ANNOUNCEMENTS
US 90 OVER ST. LOUIS BAY
12/15/2005

PROPOSED TYPICALS ST. LOUIS BAY BRIDGE

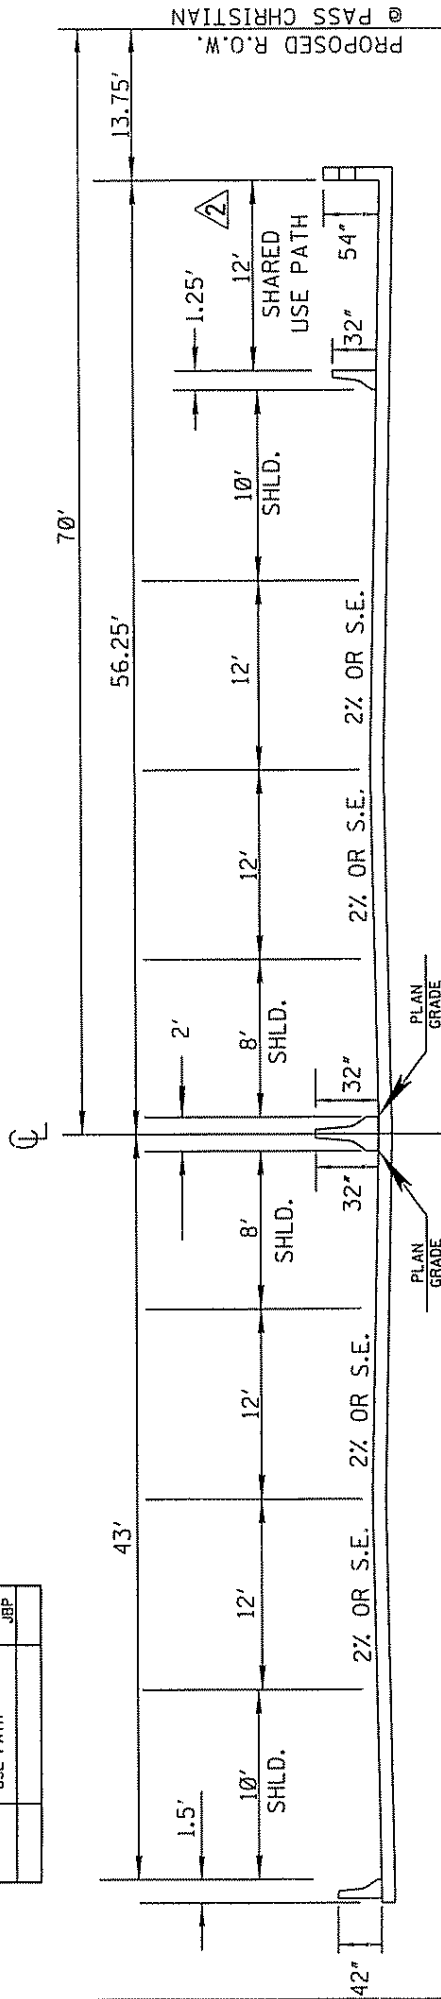
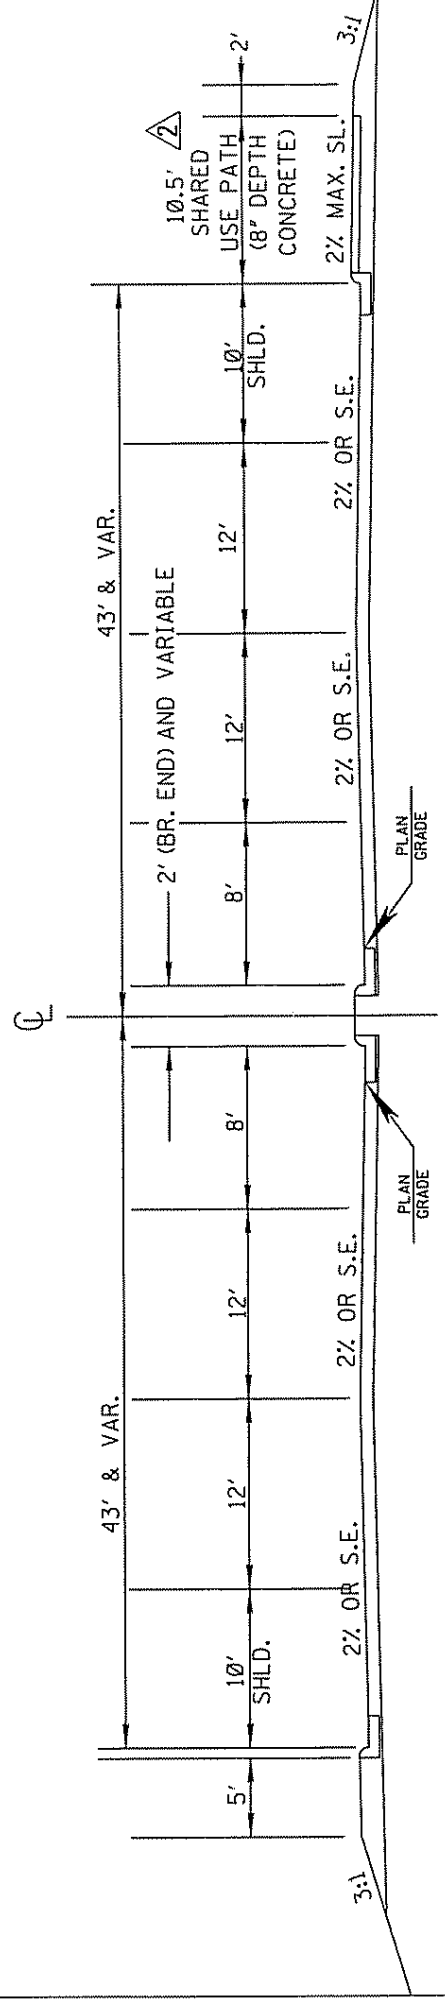
1. The requirements for the bridge typical section for this project have been modified to include a Shared Use Path (bicycle/pedestrian) on south side of the Bay Bridge and adjacent roadway sections (see attached Typical Section). Exact requirements for the Shared Use Path will be specified in Addendum No. 2. Proposers may review RFP Addendum No.1 for US 90 Biloxi Bay project (gomdot.com), which has similar requirements for a Shared Use Path. Please note that unlike the Biloxi Bay bridge, which is to have 6 travel lanes, the bridge typical section for the St. Louis Bay project will remain 4 travel lanes.

REVISIONS		
DATE	DESCRIPTION	BY
11-02-05	B.O.P. / E.O.P., BARRIER HEIGHT	JBP
12-14-05	ADDED SHARED USE PATH	JBP
